CITY OF CODY
PLANNING, ZONING AND ADJUSTMENT BOARD
TUESDAY, MARCH 9, 2021
CITY HALL COUNCIL CHAMBERS @ 12:00 NOON

MEETING DATE:	MARCH 9, 2021	TYPE OF ACTION NEEDED	
AGENDA ITEM:		P&Z BOARD APPROVAL:	
SUBJECT:	KOA PLANNED UNIT DEVELOPMENT SITE PLAN REVIEW. SPR 2021-03	RECOMMENDATION TO COUNCIL:	X
PREPARED BY:	TODD STOWELL, CITY PLANNER	DISCUSSION ONLY:

PROJECT:	CODY KOA — NORTHEAST EXPANSION
TITLE:	TITLE SHEET

MEETING DATE:	MARCH 9, 2021	TYPE OF ACTION NEEDED	
AGENDA ITEM:		P&Z BOARD APPROVAL:	
SUBJECT:	PRELIMINARY PLAT OF THE MUSSER-BEACON HILL COMMERCIAL SUBDIVISION. SUB 2021-02	RECOMMENDATION TO COUNCIL:	X
PREPARED BY:	TODD STOWELL, CITY PLANNER	DISCUSSION ONLY:

PROJECT: CODY KOA — NORTHEAST EXPANSION
 TITLE: EXPANSION SITE PLAN

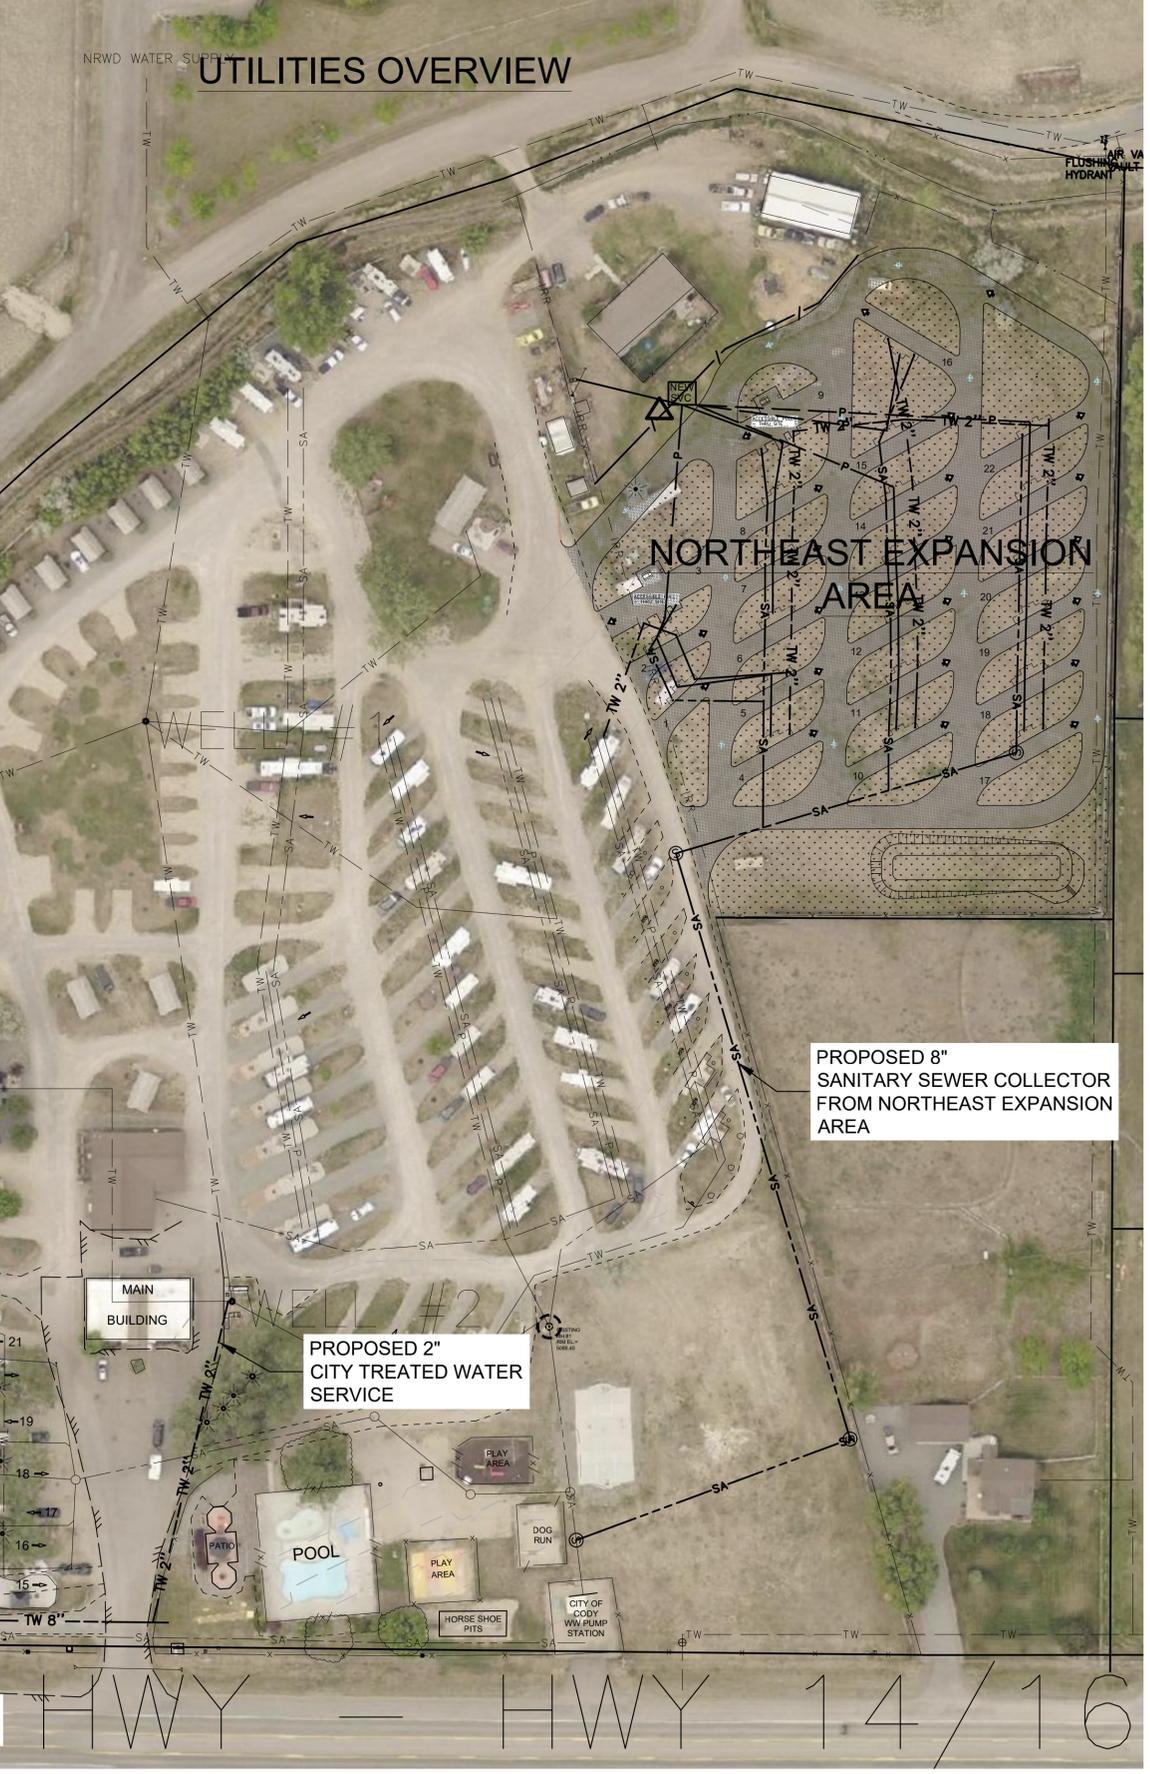
An engineered storm water plan has provided. While the concept is fine, the calculations were made based on grass camping areas, not landscape gravel. As gravel has a higher runoff coefficient than grass, the calculations need to be redone and the stormwater swale modified as necessary.

8. The access drive at the north end of the westernmost row must be redesigned to provide a minimum 20-foot inside radius and a 34-foot outside radius.

9. Update the stormwater calculations to reflect the gravel surfacing and concrete patios. Modify the size of the stormwater swale accordingly, and provide a dissipation facility for the overflow to minimize erosion and avoid point discharging to the property below.

PROJECT:	CODY KOA - NORTHEAST EXPANSION
TITLE:	UTILITY PLAN

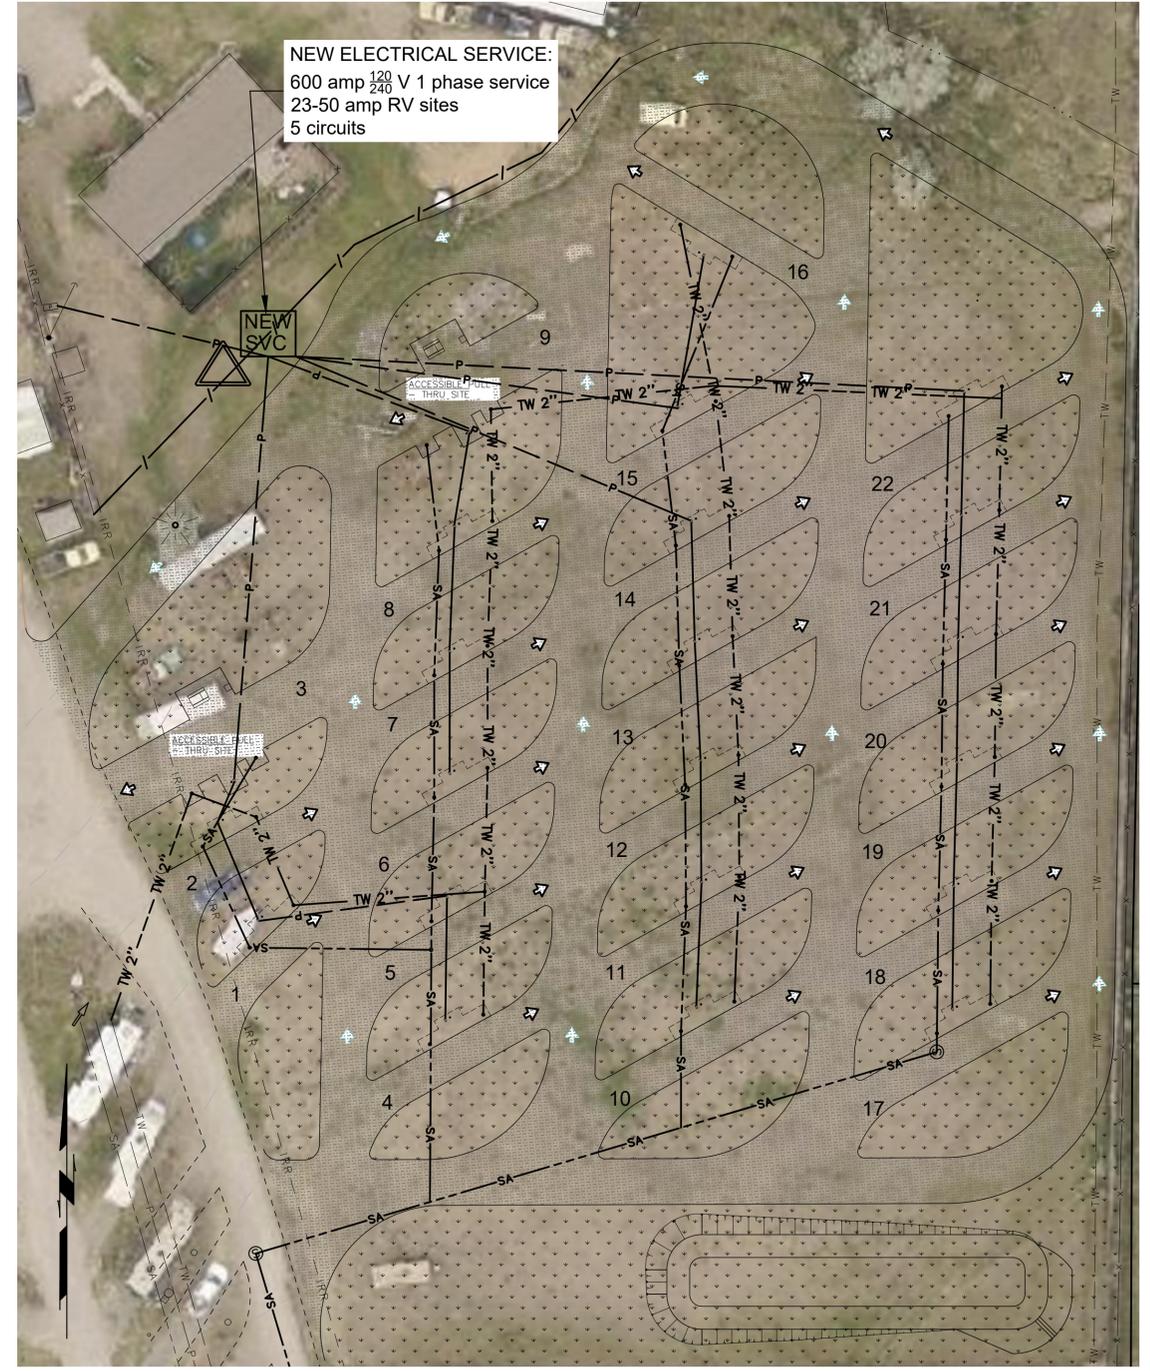
An existing 4" irrigation service runs along the west side of the project to the neighbor to the south. The line has been identified on the plans, so that it can be protected.

5. Verify domestic water service line and meter size. Applicable utility fees will be collected before City water is activated.
6. Move the transformer to a more central location, as agreeable to the electric division. Update the electrical plan for electric division review prior to installation of electrical system.

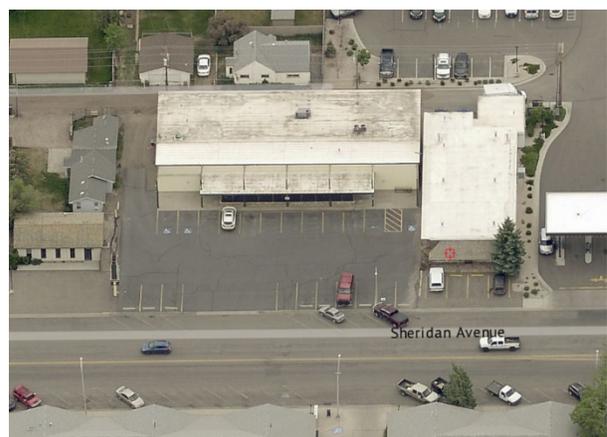
It needs to be pointed out that the 100 seats shown are much, much less than the capacity of the building. For example, the central bar area and the bar area in front of the brewery area only show 10 seats. However, using a realistic spacing of 30" (center to center) for the bar areas, they would have a capacity of 33 seats. The tables also show extra spacious seating. Seating charts used in the restaurant industry are generally broken into "family dining" which provides a comfortable 30" spacing on center, and quick turnover (think fast food) which provide a 24" spacing on center. Using the "family dining" spacing for the tables reveals that the 9-foot-long tables to the left of the main bar actually can each seat 10, not the six shown. The smaller indoor tables can generally accommodate two seats more at each table than shown. The claimed seating capacity also does not include the party room, which would have a capacity of 39 persons based on one person per 15 square feet. Employees are also not considered in that ratio. For these reasons, staff is not comfortable accepting the claim that only 30 parking spaces would be required for this facility.

For purposes of advertising the public hearing, it was identified that the seating capacity of the facility was around 171 persons (99 at tables, 33 at bars, and 39 in the party room). Those numbers represent using the seats shown at the tables on the plan, the 30" spacing at the bars, and the 39 persons in the party room. The number of parking spaces required as purposely not identified in the notice, due to the large discrepancy in calculations.

If the 0.3 parking spaces per seat were applied to 171 seats, it would mean 51 spaces would be needed. 22 spaces are proposed to be provided.
